SUBJECT: Forwards addl info requested in 851120 telcon re auxiliary  
 pressurizer spray sys, including pressurizer vent sys  
 description & charging pump operation to permit issuance of  
 Unit 2 OL.

Subject: Palo Verde Nuclear Generating Station (PVNGS)  
Units 1, 2, and 3  
Docket Nos. STN 50-528 (License No. NPF-41)/529/530  
Additional Information on the PVNGS Auxiliary Pressurizer  
Spray System (APSS)  
File: 85-056-026; G.1.01.10

# PRESSURIZER VENT SYSTEM

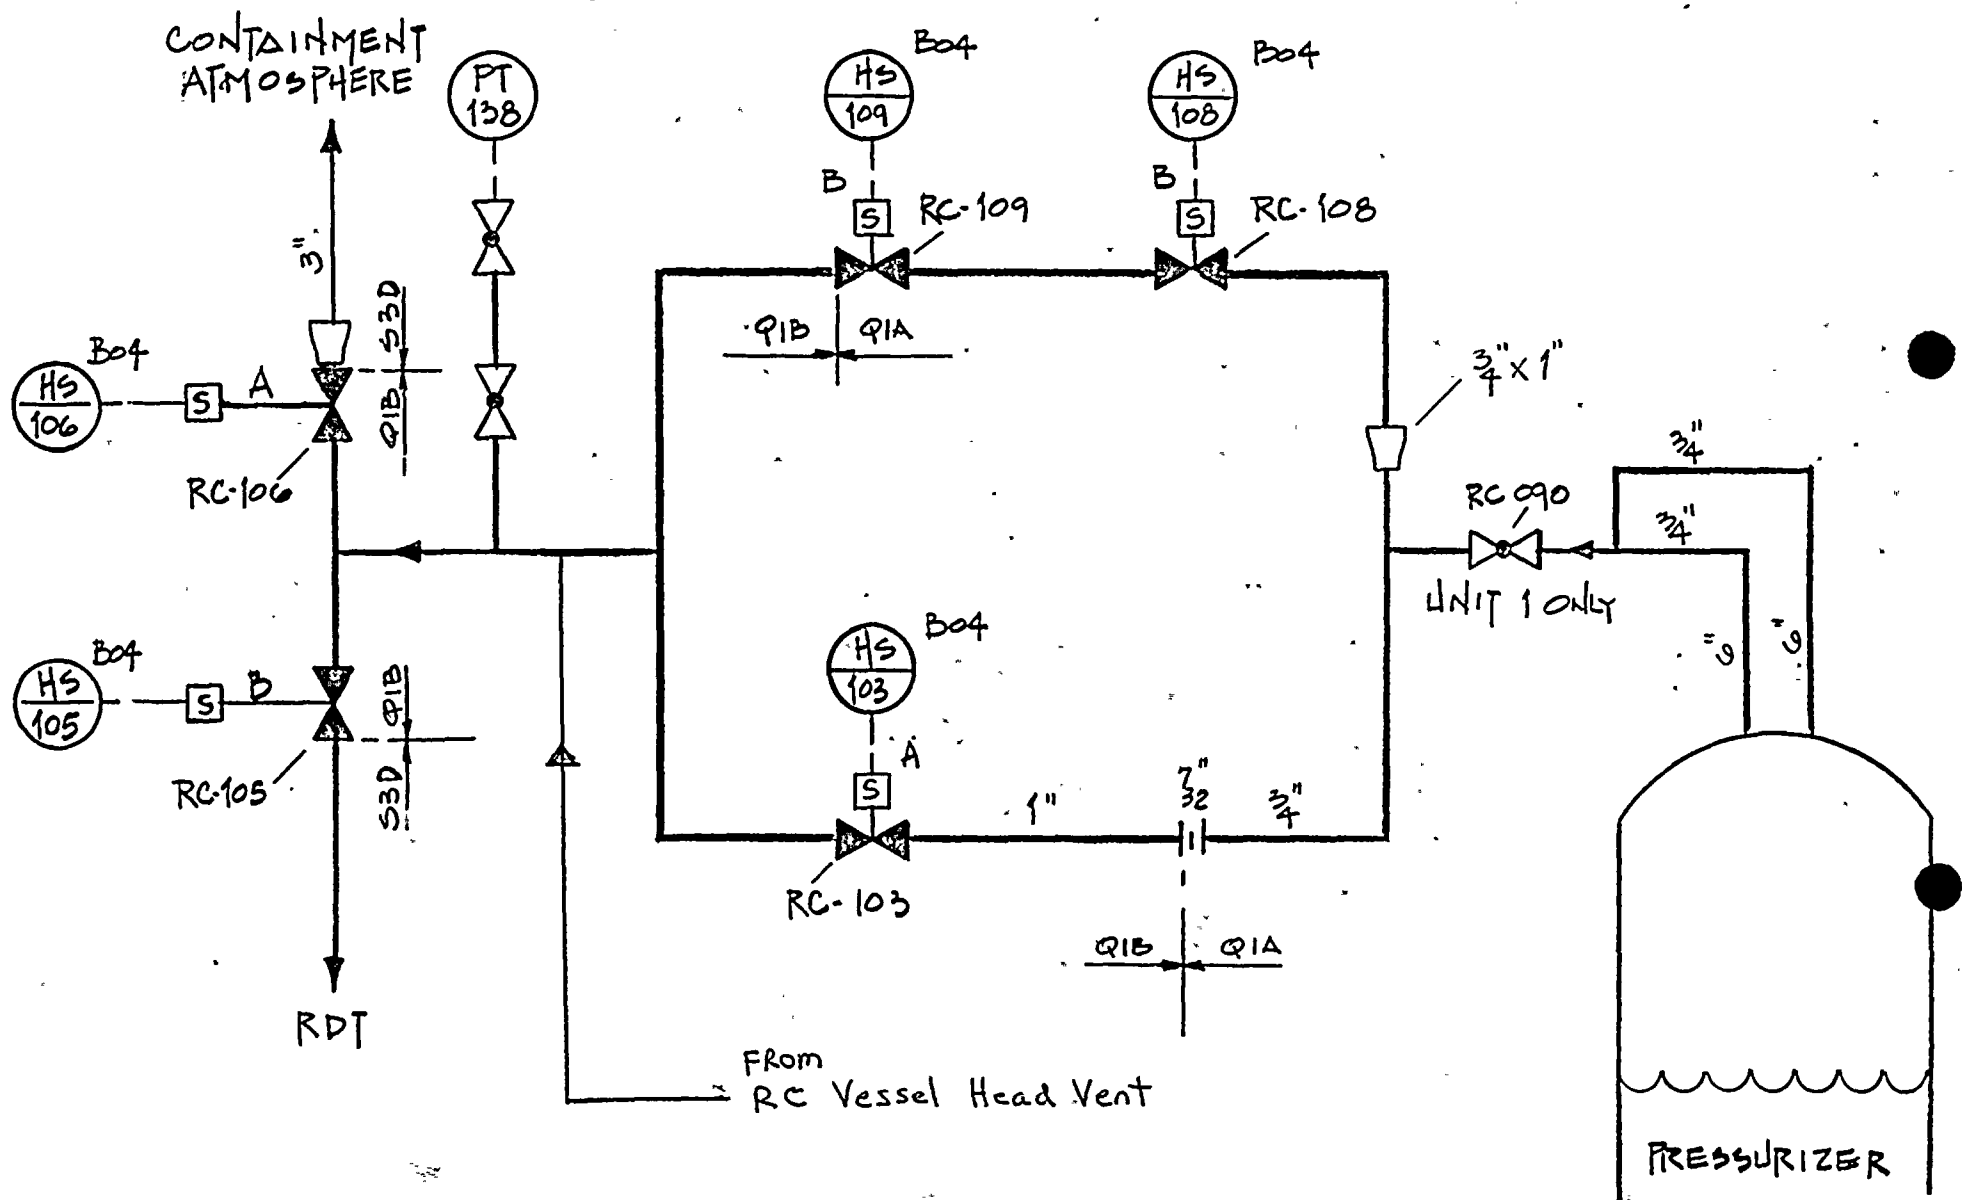
\* Attachment 1  
Description of Pressurizer Vent System

The pressurizer vent portion of the reactor coolant system vents is shown in the figure included within this package. The system includes all piping and components from the pressurized steam space up to and including valves RC-105 and RC-106. As shown on the attached figure, the system consists of two flow paths from the pressurizer steam space. The first of the flow paths is composed of two remotely operated solenoid valves (RC-108 and RC-109) which are powered from B-train power supplies. The second flow path consists of a 7/32-inch orifice and one remotely operated solenoid valve (RC-103) which is supplied by A-train power supplies. Either of these flow paths from the pressurizer steam space is capable of relieving directly to the containment atmosphere or to the Reactor Drain Tank (RDT) through one remotely operated solenoid valve from each direction.

The pressurizer vent system is a safety grade system with the exception of pressure transmitter PT-138. This pressure transmitter is a non-safety related instrument which is not required for the safe operation of the system. This pressure indication in the vent line downstream of the reactor vessel head and pressurizer isolation valves is provided to detect leakage past any of these valves during normal power operations and alarm to alert the operator of the leakage. For a further description of the pressurizer vent system, please refer to Item II.B.1 of Reference (B).
